2023 Financial Assurance Estimate Form (with pre-plat construction)

PROJECT INFORMATION		
Mayberry Filing No.4	8/15/2023	SF2317
Project Name	Date	PCD File No.

Mayberry Filing 4 proposes the construction of Business Park, a Urban Local roadway, and associated infrastructure as well as overlot grading 8 sites for future commercial use. A temporary cul-de-sac is proposed at the eastern end of Business Park as a placeholder for future improvements. Channel E, which is designed in Mayberry Filing 3, will be redirected and placed outside of the Filing 4 property. The existing channel section is maintained, and no additional flow is added to the channel.

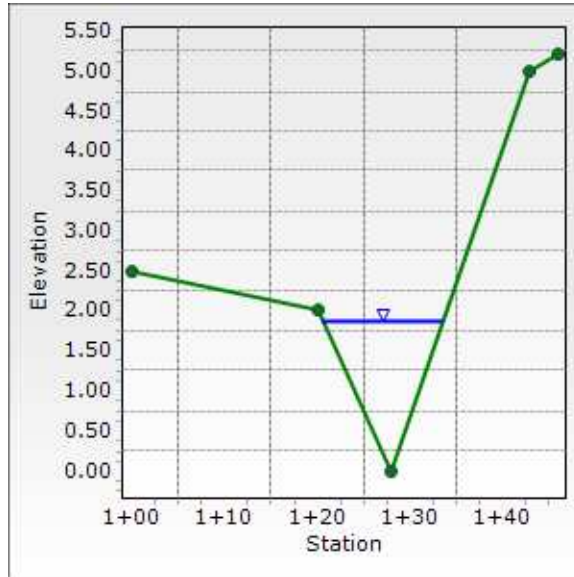
Project Description		
Friction Method	Manning Formula	narrative and drainage plan indicate a 5 year flow of 13.14 cfs. revise accordingly
Solve For	Normal Depth	
Input Data		
Channel Slope	0.001 ft/ft	
Discharge	9.89 cfs

Swale C7 has been modified in geometry and the flow has been revised to 13.14 for the 5-year.

Temporary Swale C7 Cross Section - 100 year

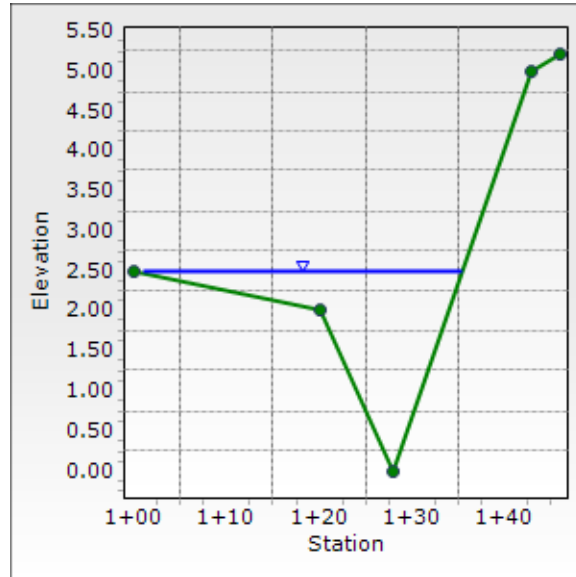
Project Description		narrative and drainage plan indicate a 100yr flow of 23.97 cfs. revise accordingly. Increase the drainage easement as necessary to contain the 100yr flow.
Friction Method	Manning Formula	
Solve For	Normal Depth	
Input Data		Swale C7 has been modified in geometry and the flow has been revised to 23.97 for the 100-year.
Channel Slope	0.001 ft/ft	
Discharge	18.04 cfs

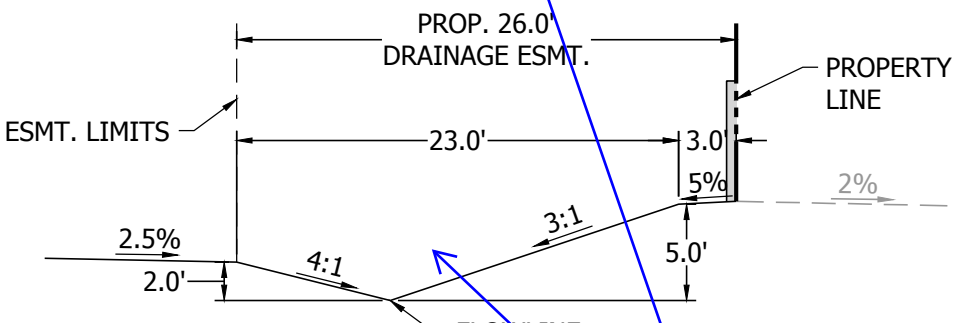
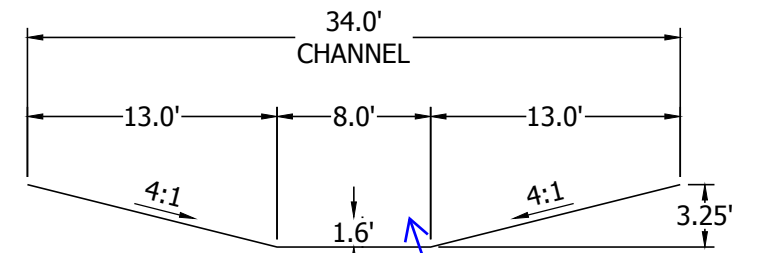
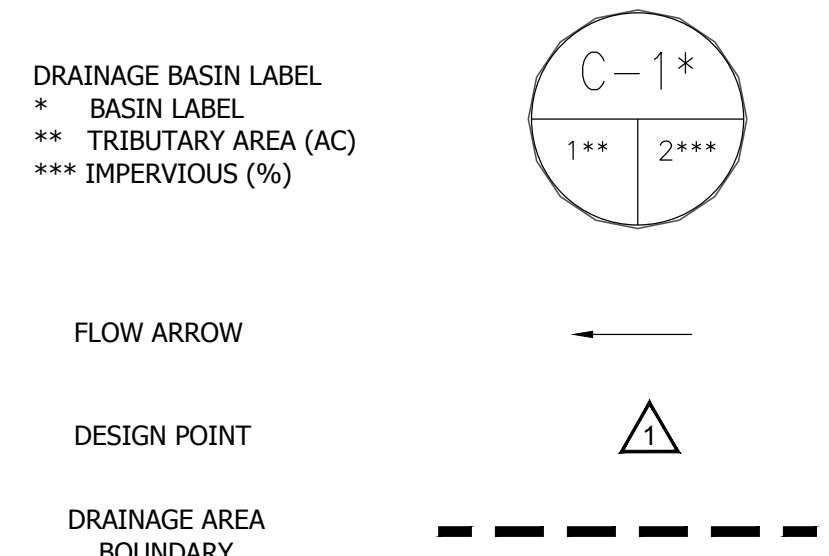
show the 100 yr WSE on the details
